# FIRE SAFETY INSPECTION REPORT

**FUJI KNITWEARS LIMITED**

**ACCORD ID: 12656**

**Date: 12 March 2017**

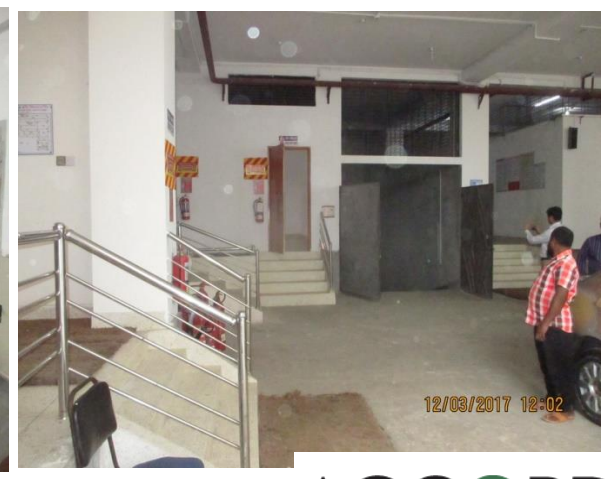
F-3	Fire Rated Construction	Unsealed electrical shafts are located in the fire-rated floor/ceiling assemblies.	Provide a minimum 2-hr fire rated shaft to separate the utility risers from each floor level and seal all penetrations in floor/ceiling assemblies to maintain the fire separation.	Within 3 months
-----	-------------------------	--	---	-----------------

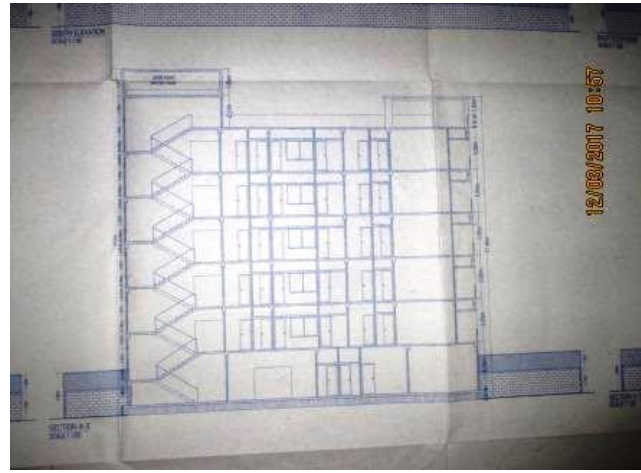
F-14	Fire Alarm & Detection System	Inspection, testing, and maintenance for the fire alarm system were not in accordance with NFPA 72.	Inspect, test and maintain the fire alarm system, and keep written records on-site, in accordance with NFPA 72.	Within 1 month (after installation)
F-15	Fire Protection	The required standpipe system is not installed in accordance with the ACCORD standard.	Install a new standpipe system in accordance with ACCORD standard 5.4 and NFPA 14. A class III system shall be installed in buildings with the highest Occupiable floor 10 m (33 ft.) above grade or more. A class I system shall be permitted in buildings protected throughout by an approved automatic sprinkler system.	Design within 4 months, install within 9 months
